# Comhairle Chontae Atha Cliath Theas

## Record of Executive Business and Chief Executive's Order

**Reg. Reference:** SDZ22A/0018      **Application Date:** 15-Dec-2022  
**Submission Type:** Clarification of      **Registration Date:** 06-Oct-2023  
Additional  
Information

**Proposed Development:** Construction of a mixed-use development comprising 594 apartments, office floorspace, 4 retail units, a creche and urban square in the Clonburris Development Areas CUCS3 & CSWS3 of the Clonburris SDZ Planning Scheme 2019 as follows, 594 apartments (255 one bedroom apartments, 307 two bedroom apartments and 32 three bedroom apartments (all apartments to have terrace or balcony; ancillary communal amenity spaces for residents) as follows; Block A (4 and 6 storeys with undercroft) comprises 96 apartments consisting of 36 one bedroom apartments, 48 two bedroom apartments and 12 three bedroom apartments (with creche c. 609sq. m at ground and first floor as well as play area; Block B (6 storeys with undercroft) comprises 77 apartments consisting of 44 one bedroom apartments, 28 two room apartments and 5 three bedroom apartments; Block D (5 and 7 storeys with undercroft) comprises 71 apart

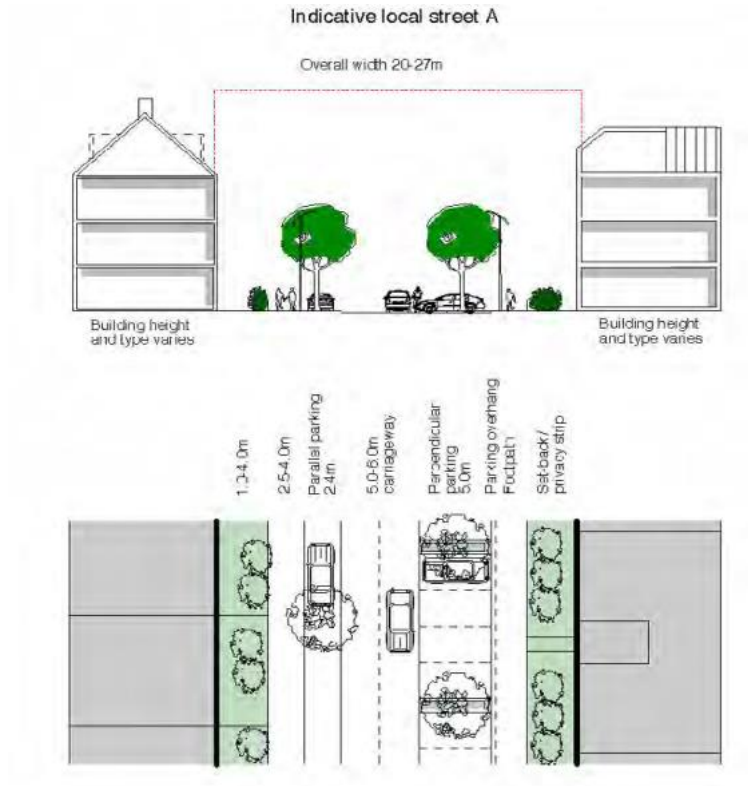
It is noted that there is a wayleave to the east and the building frontage at this location has to be stepped back from the road. Blocks C and A also provide a strong perimeter frontage. It is noted that the scheme envisages a perimeter block to the south, where blocks E and F are located. It is noted that there is a break in this frontage at present and also that Block F is set off the southern link road. There do not appear to be any physical constraints to providing a strong frontage at this location. The applicant is requested to address this via **additional information**. It is noted that there is a break in the railway frontage and an element of single storey, however, it is considered that overall, Blocks G and H meet the requirements for railway frontage.

The subject application largely maintains the Local Street alignments indicated in the Planning Scheme to provide a Railway frontage to the north and Avenue frontage to the west.

**Figure 2.2.6** Example Local Streets including Homezones (Intimate Scale)

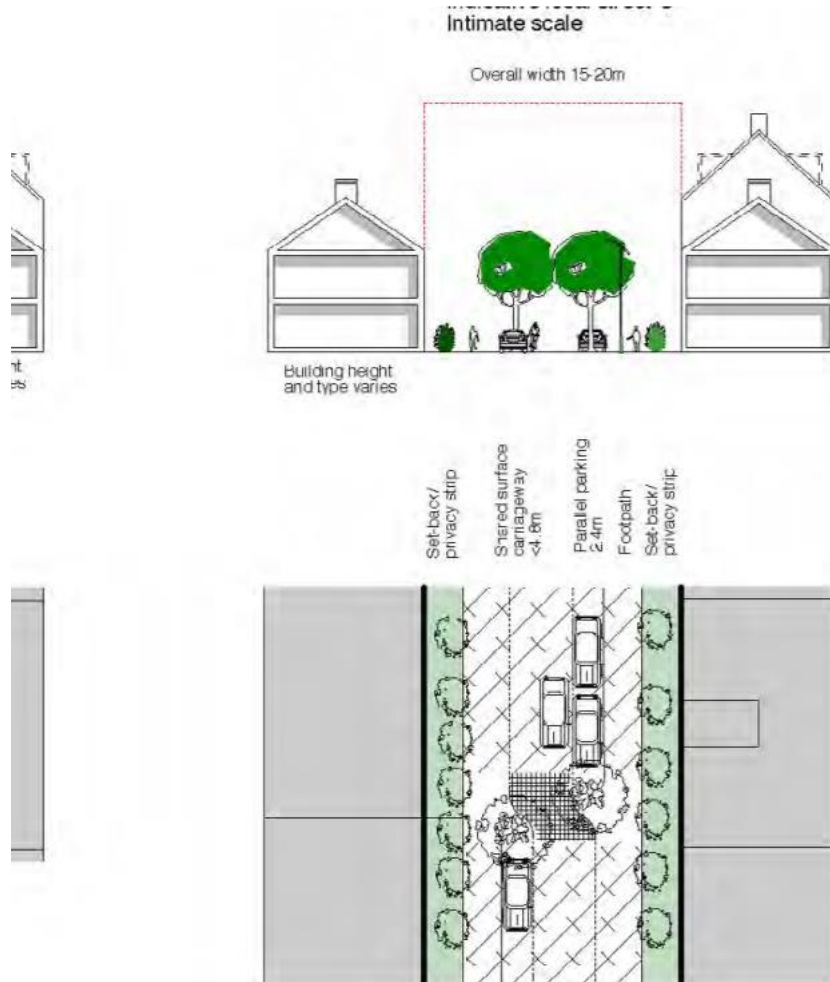
The applicant is requested to provide a clear layout plan indicating:

- The road typology
- Width between building frontages (including areas with planning permission or under consideration applications)
- Carriageway width
- Footpath width
- Privacy strip width (if present)
- Location of street trees.
